TO: Service Locations

FROM: Service Systems Development

SUBJECT: **GHG17 Heavy Duty Engine Platform 1-BOX[™] Aftertreatment System (ATS) Wire Harness**

Figure 4 – Harness Clip Removal

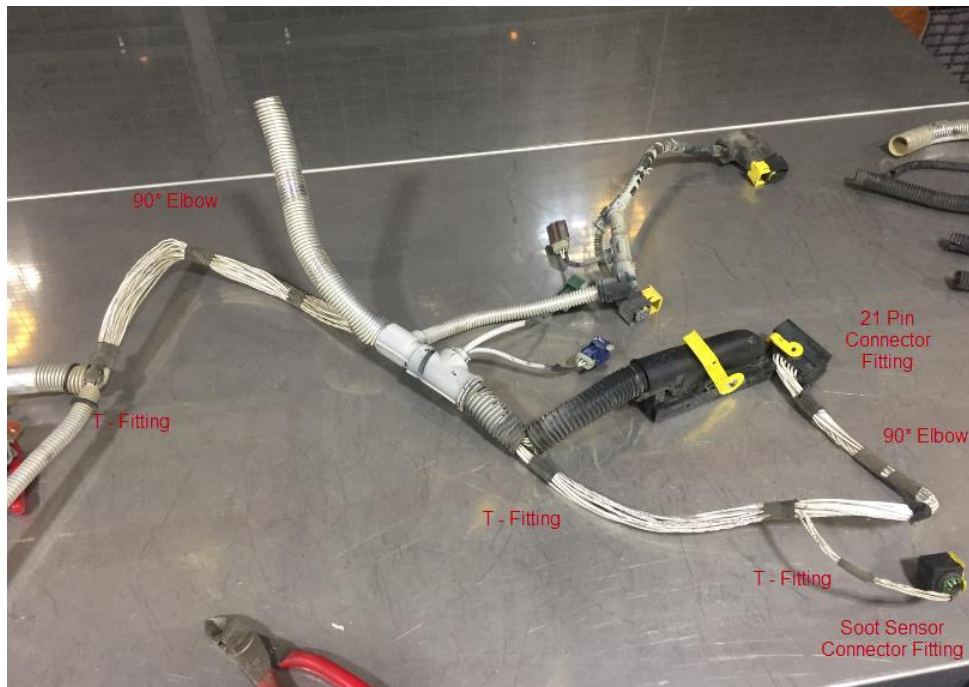
6. Remove the following plastic connector clips. Reference Figure 4.

- Two 90-degree elbows
- Three T-fittings
- 21-pin connector fitting
- Soot Sensor fitting

Figure 6 – Convoluted Tubing Removal

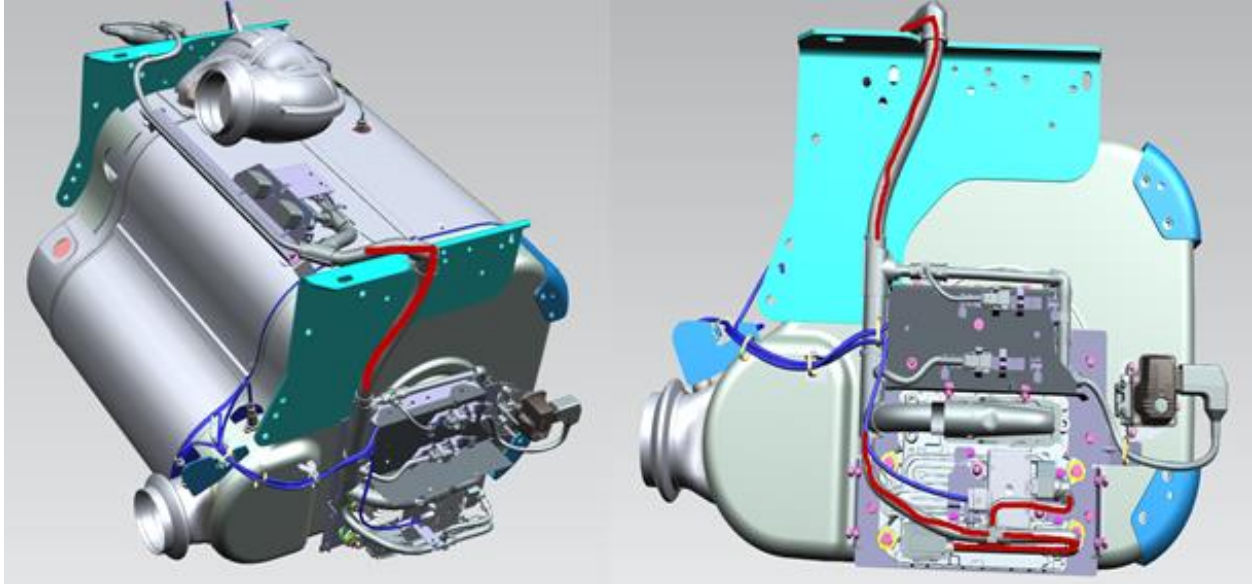
8. Carefully remove all convoluted tubing shown in red below. Reference Figure 6.

Figure 8 – ATS Harness 21-pin and 120-pin Connector Inspection

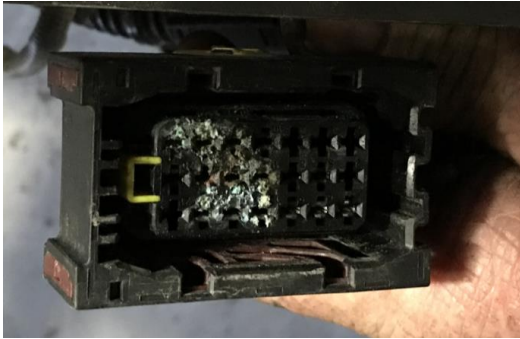
10. Inspect the ATS harness 21-pin and 120-pin connectors for excessive corrosion. Reference Figure 8. Is excessive corrosion present at one or both connectors?
- Yes; replace the ATS harness. Reference the removal and installation sections for the 1-BOX™ Aftertreatment Harness in the *GHG17 Heavy Duty Workshop Manual* (DDC-SVC-MAN-0190). Instructions for adding anti-chaffing tape are further below.
 - No; the harness will be reused.
